**Re: Fishers Cove Land Use Application
Burke & Rutecki, LLC**

STAFF REVIEW

Application Title	Fishers Cove
Application Type	Preliminary Consent - Major Subdivision
Owner	Burke & Rutecki, LLC
Tax Map and Parcel	SC Tax Map# 335-4.00-15.00
Size and Location	11.08 acres and located off Rodney Avenue, southwest of Pilottown Road
Comprehensive Plan Designation	Residential
Zoning District	R-2 – Residential Low-Density
Present Use	agriculture/vacant
Proposed Use	18 additional residential dwellings
Online application material	https://lewescommissions.wordpress.com/reviews/dev_reviews/fishers-cove/

Re: Fishers Cove Subdivision
Preliminary Consent Review – Resubmitted Plans
Lewes, Delaware
GMB File No. R180225

TRIP GENERATION - PILOTTOWN ROAD (S-267) AND RODNEY AVENUE

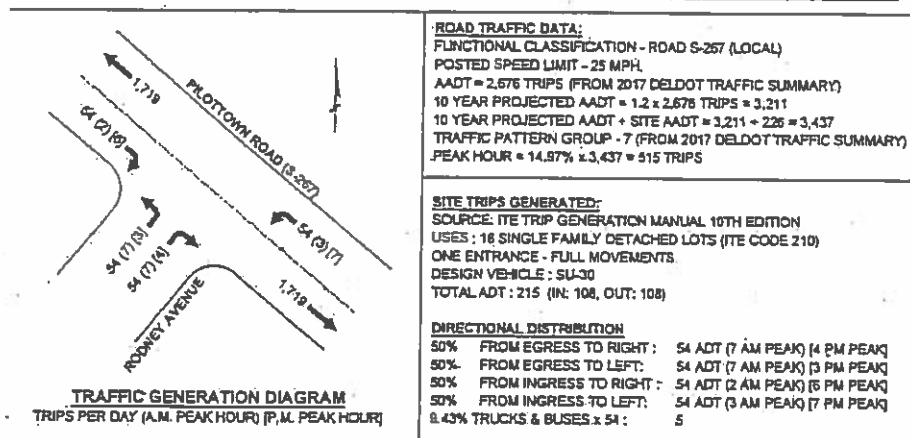
Included within the plan application is a panel that describes traffic generation and distribution. The information indicates that the development would result in an additional 215 average daily trips per day. As suggested in the panel distribution of the current and additional traffic (estimated to be 500 average daily trips), at the intersection of Rodney Avenue with Pilottown Road, would be evenly split (see Trip Generation image below).

The plan shows the proposed cartways and ROW lines. Additional details on cartway width, curb radii, sight distance, curbing and sidewalks (required by code on both sides of all streets) are addressed

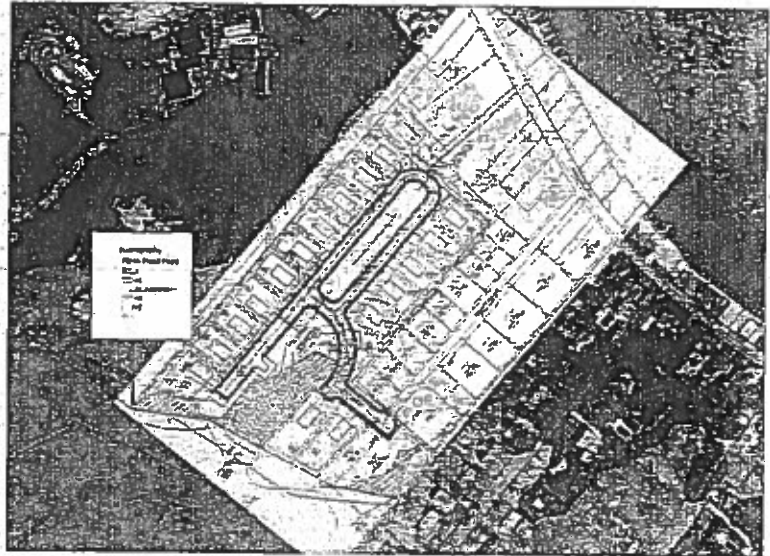
Although the State manual references the use of bio-retention systems as a viable stormwater management approach it also identifies numerous criteria that appear to be inconsistent with the application as currently proposed, such as:

- Locational criteria which suggest bio-retention facilities should be cited outside of the 100 year floodplain and above seasonal high water table levels; and
- Facilities should contain minimum areas for maintenance (15' buffers) and use of multiple spreader outlets to reduce scouring, that do not appear to be included in the current proposal.
